Title		
Phoenix Theremin 2020 - Front panel		
Size	Number	Revision
A4	Humorous words of wisdom ...	1.07.19A
Date:	21. 01. 2019	Sheet of
File:	H:\FAKS\...FrontPanel.SchDoc	Drawn By:

Title		
Phoenix Theremin 2020 - Pitch board, audio section		
Size	Number	Revision
A4	... from our faculty:	1.07.19A
Date:	21. 01. 2019	Sheet of
File:	H:\FAKS\...\PitchBoard - AudioSection.Sch

Title		
Phoenix Theremin 2020 - Pitch board, RF section		
Size	Number	Revision
A4	Theoretically speaking, ...	1.07.19A
Date:	21. 01. 2019	Sheet of
File:	H:\FAKS\...\PitchBoard - RF_Section.Sch Drawn By:

Phoenix theremin 2020  
 Prototype for a single board revision  
 (revision B1)

### VOLUME BOARD

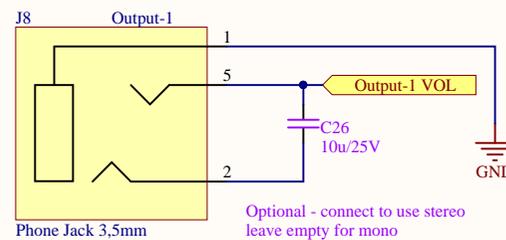
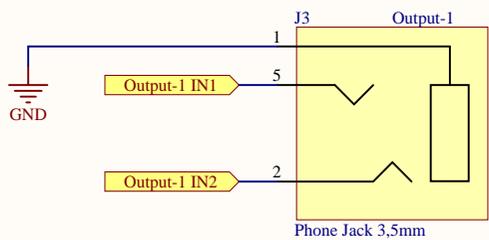
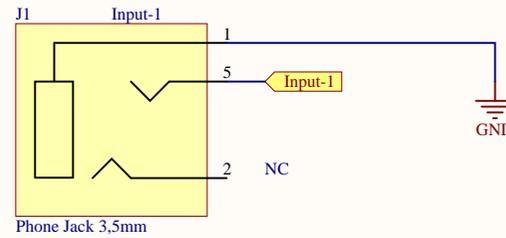
This connector should be replaced by a standard power connector. TRS jack is not really appropriate for supplying power

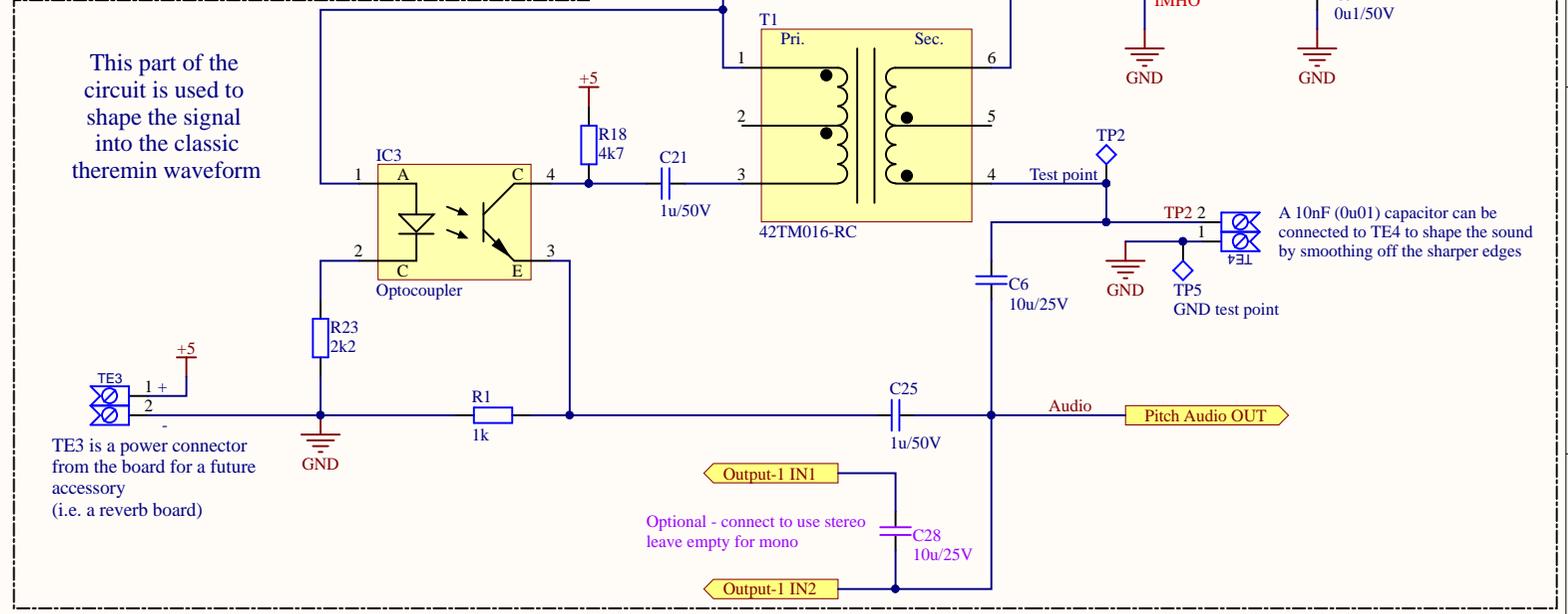
Ground connection from J2 pin 1?

This looks nicer IMHO

### Fixed pitch, L2 oscillator f = 900KHz

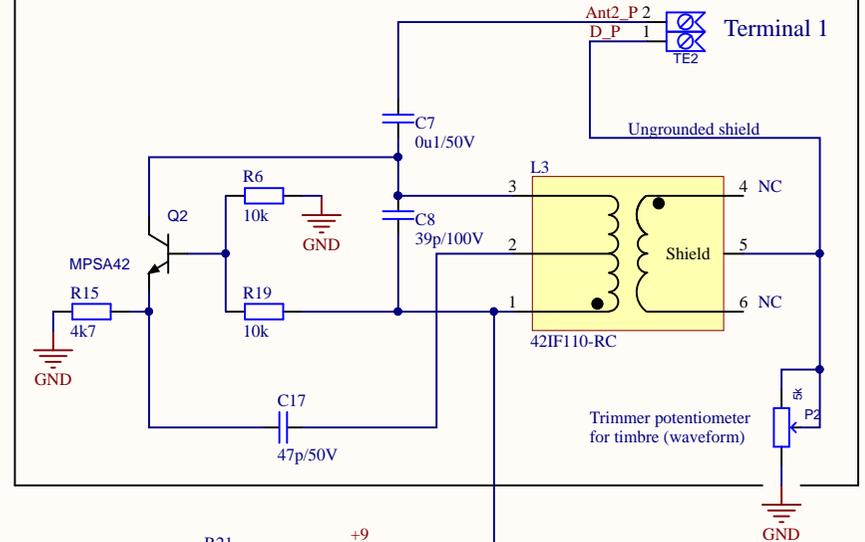
How should I name the connector in the place of Ant2\_P? This is the marking I see on the website.

Title			
Phoenix Theremin 2020 - Power supply			
Size	Number	Revision	
A4	... practice and theory ...	1.07.19A	
Date:	21. 01. 2019	Sheet	of
File:	H:\FAKS\...\PowerSupply.SchDoc	Drawn By:

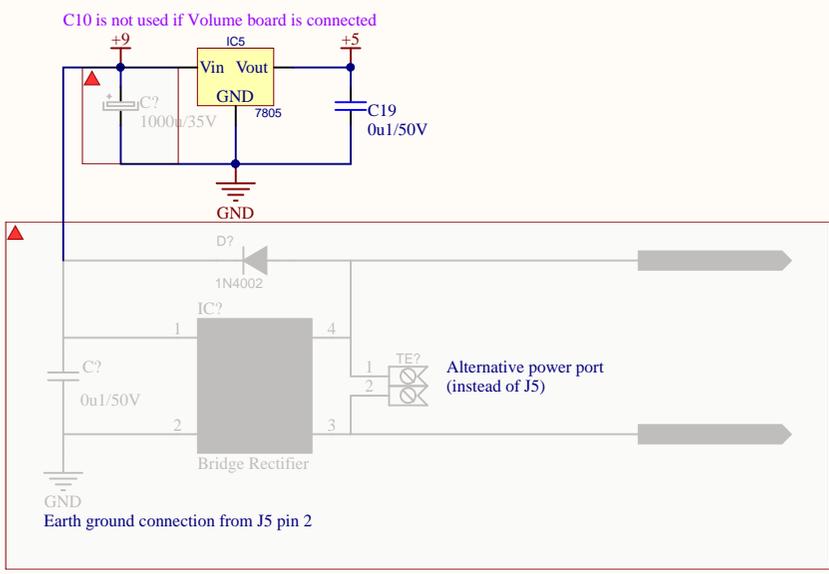
I will remove the greyed out areas.  
 I will however, make a separate schematic for the 2 board variant and leave the appropriate parts of the circuit on the schematic.

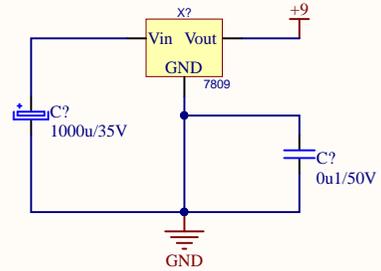
I still see this and it doesn't look right to me.  
 Did you forgot to reupload a new image  
 Or is this intended?

Title		
Phoenix Theremin 2020 - Volume board, RF section		
Size	Number	Revision
A4	... the same thing.	1.07.19A
Date:	21. 01. 2019	Sheet of
File:	H:\FAKS\...\VolumeBoard - RF_Section.SchDown By:

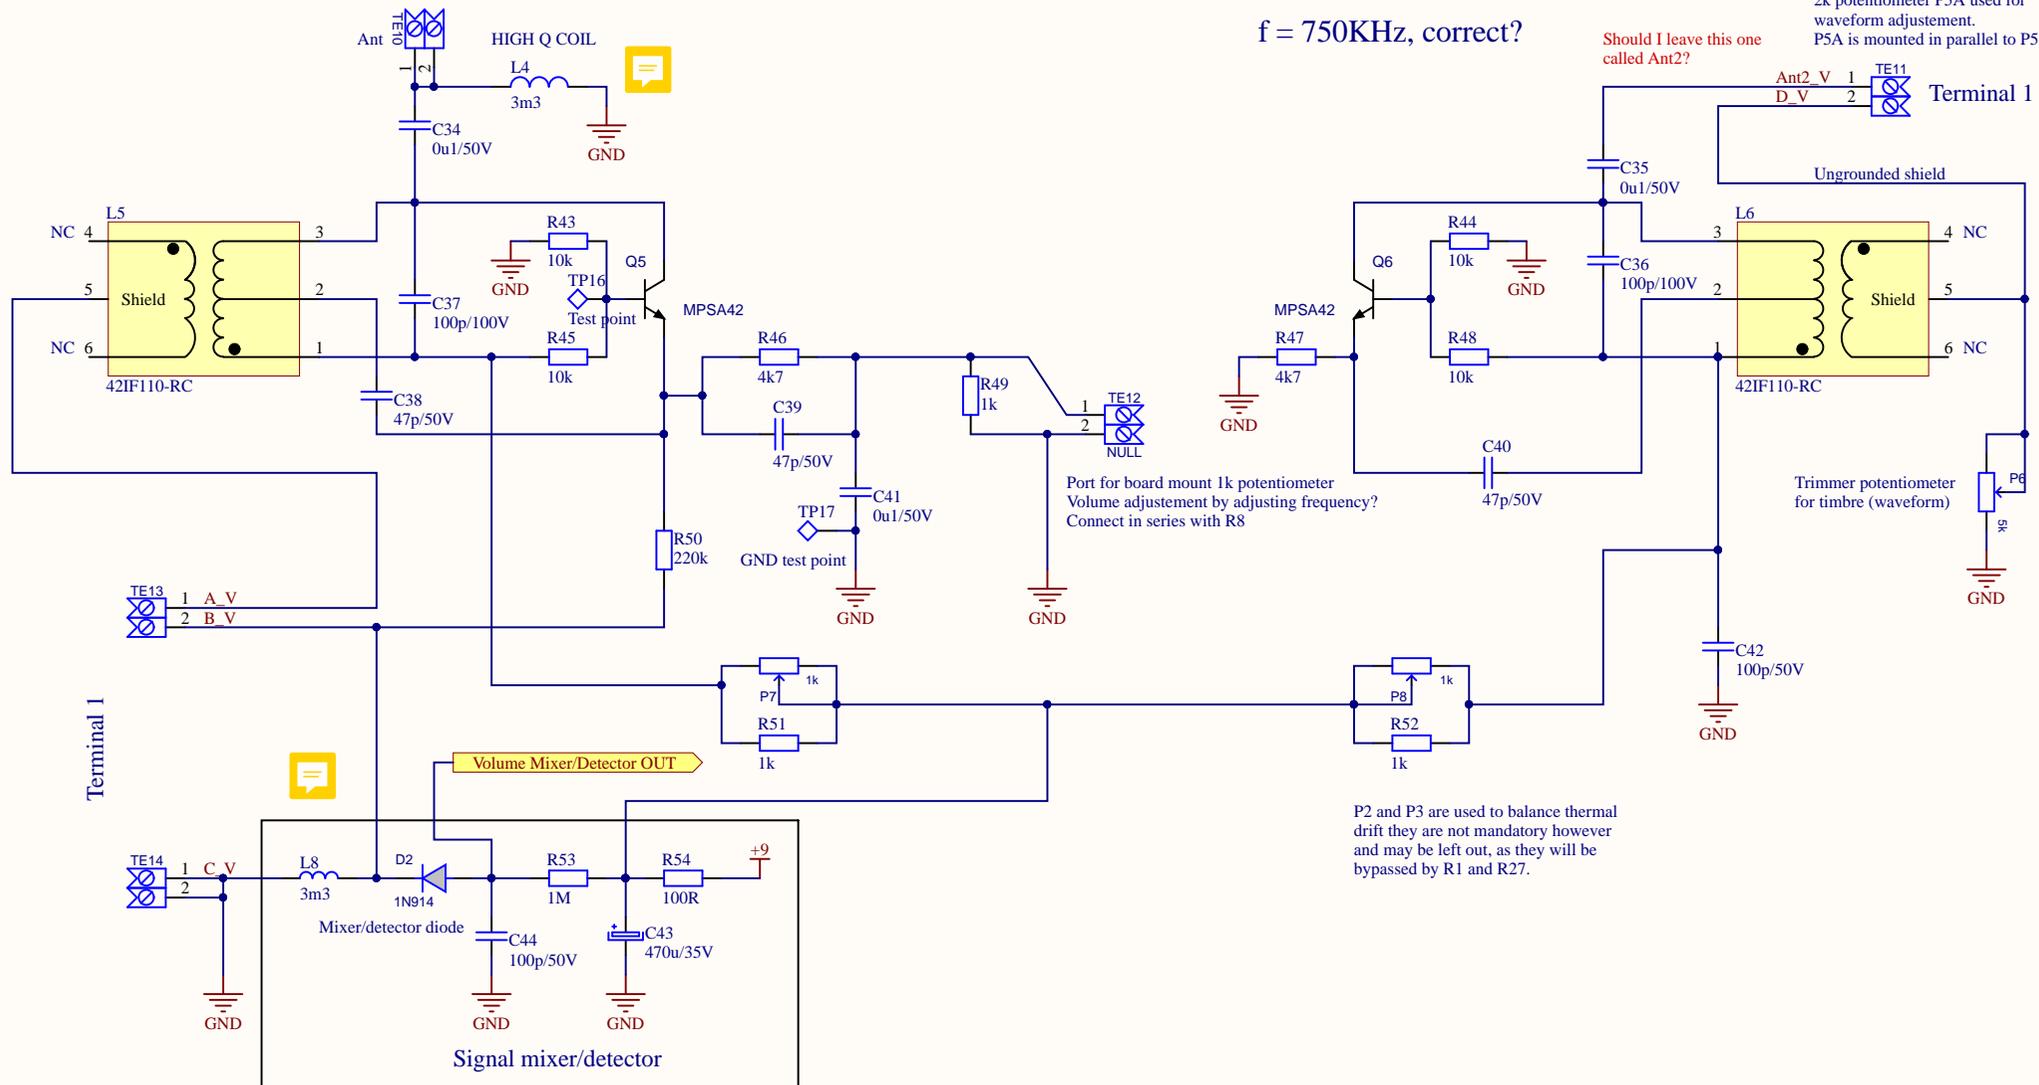
$f = 750\text{KHz}$ , correct?

Should I leave this one called Ant2?

Port for board mount 1k potentiometer Volume adjustment by adjusting frequency? Connect in series with R8
